ADDENDUM NUMBER 1:

Re: Crary Road Dirt Road Paving
Specification Number: PD 15-16.078

This Addendum #1 provides for:

PAVEMENT SECTION DETAIL
N.T.S.

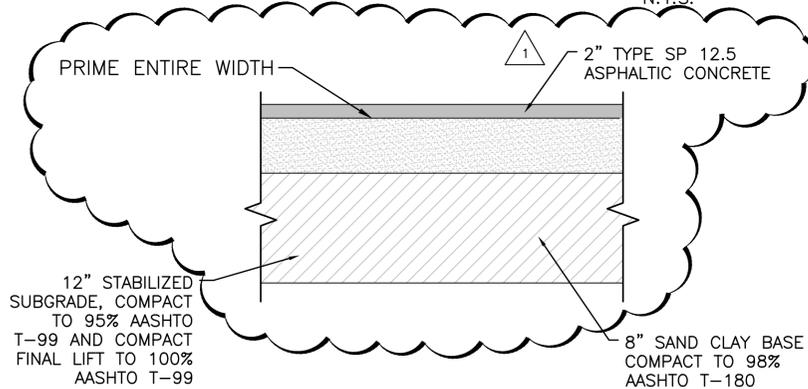
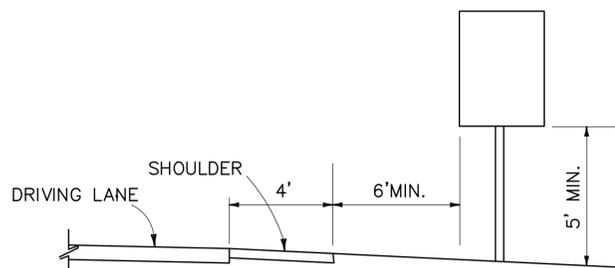
REVISION NO.	DESCRIPTION	DATE	BY:
01	REVISED ASPHALT THICKNESS	8/01/16	RGJ
